**EXH. RPB-3
DOCKETS UE-22 ___/UG-22 ___
2022 PSE GENERAL RATE CASE
WITNESS: RYAN P. BLOOD**

BAKER RIVER PROJECT
Board of Consultants Report for Meeting No. 6
Puget Sound Energy Conference Center, Snoqualmie, WA
12 - 14 December 2017

This meeting of the Board of Consultants (Board) for the Baker River Project reviewed progress on the investigation programs and analyses for the Lower Baker Dam.

Figure 1 Potential Leakage Path

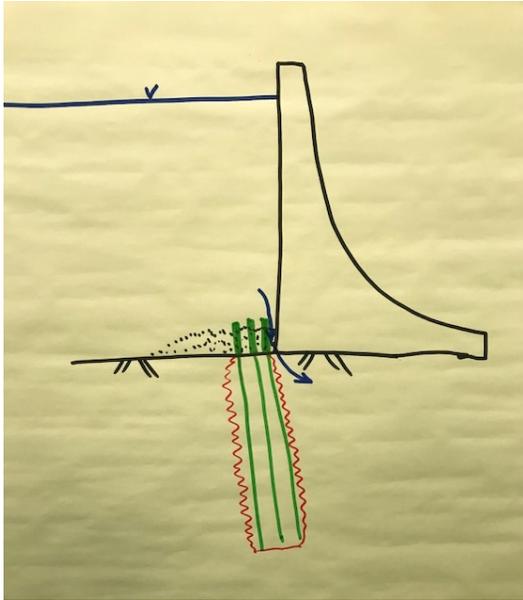
- a) Yes. Our only concern would relate to the possibility that the materials placed would in some way prove a challenge to the drilling activities for the grout curtain or the efficiency of the horizontal seal between the grout curtain and face of the dam. See Figure 1 for a sketch of a potential leakage path.
- b) Yes. Any intervention to reduce the velocity of the seepage prior to and during grouting will increase the likelihood of successfully constructing the curtain to satisfy design requirements (i.e. residual permeability of the grouted mass).
